Re: S/D 94-36 ROBBINS FARM 4TH ADDITION - (Final Plat)

Re: S/D 94-36 ROBBINS FARM 4TH ADDITION (Final Plat)

STAFF REPORT
(Final Plat, Preliminary Plat Approved 5/26/94)

CASE NUMBER: S/D 94-36 ROBBINS FARM 4TH ADDITION

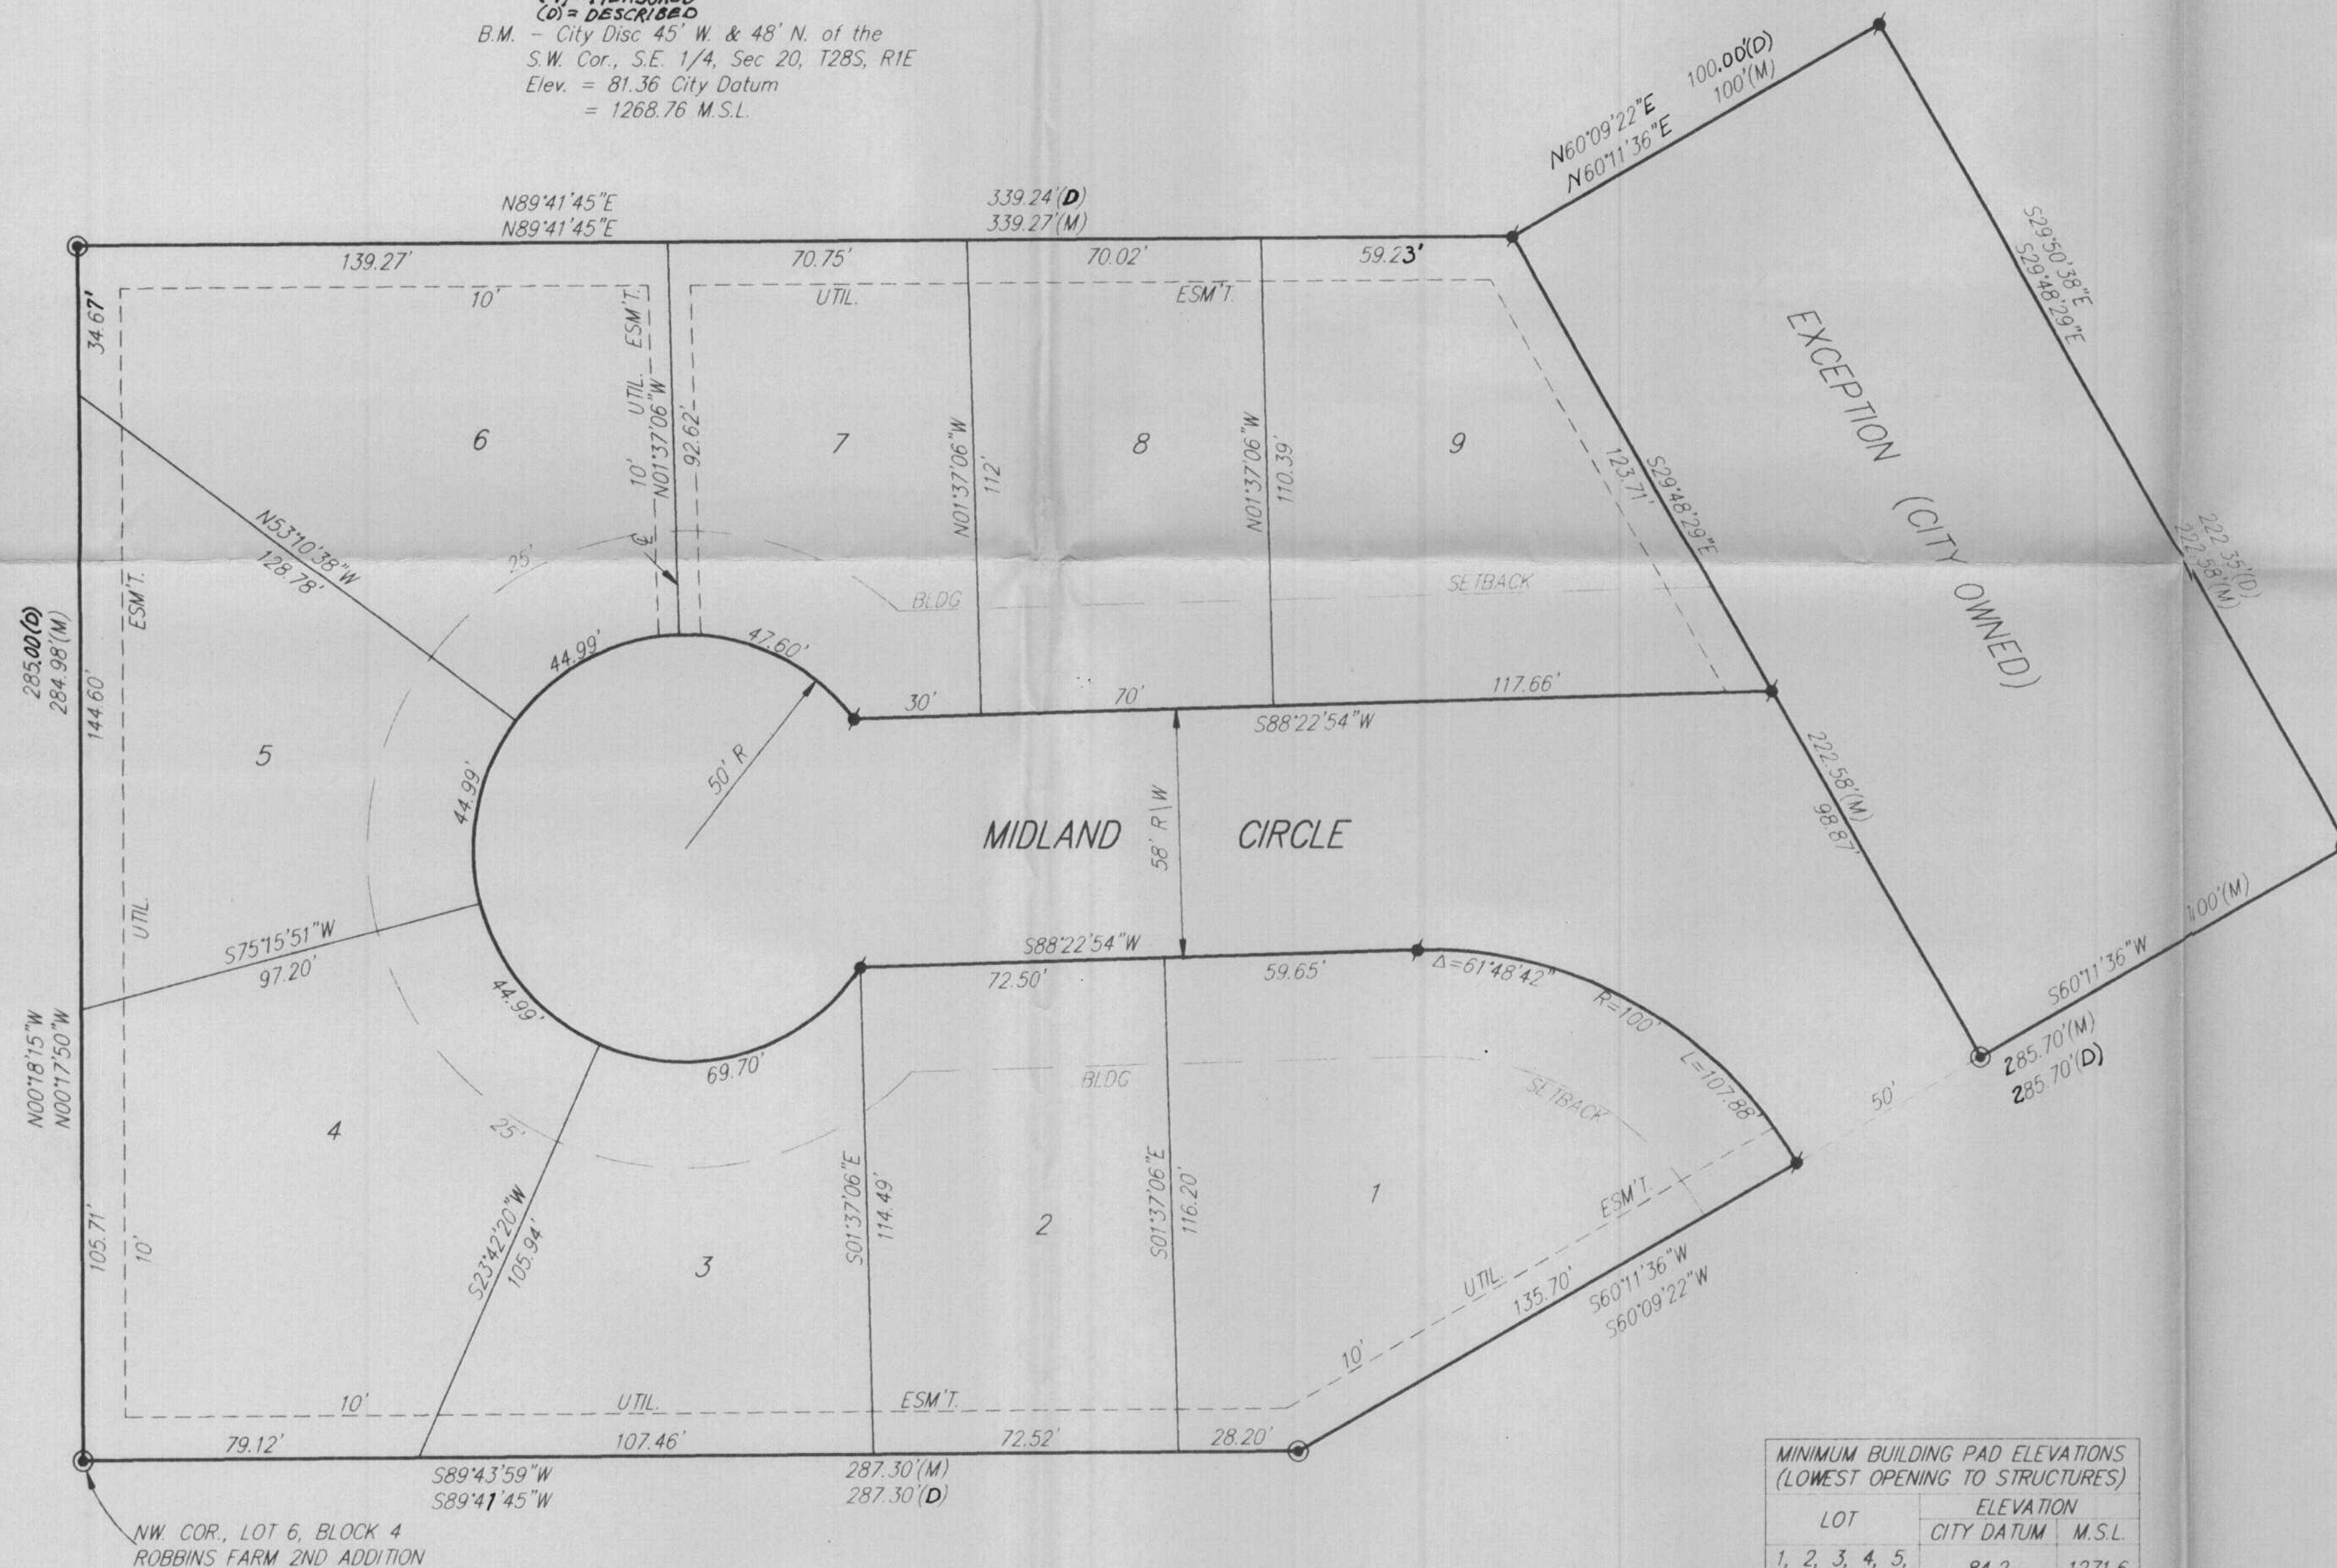
- ☒ E. Since this plat will result in Midland (street) being terminated by a cul-de-sac, the street name on the final plat tracing should be indicated as Midland Circle rather than as a Court. Also this street's terminus at the south line of this Addition should be shown with a dashed line rather than a solid line. Also, the utility easement need not be shown as crossing this street.

- F. Since this plat will result in Midland (street) being terminated by a cul-de-sac, the street name on the final plat tracing should be indicated as Midland Circle rather than as a Court. Also this street's terminus at the south line of this Addition should be shown with a dashed line rather than a solid line. Also, the utility easement need not be shown as crossing this street.
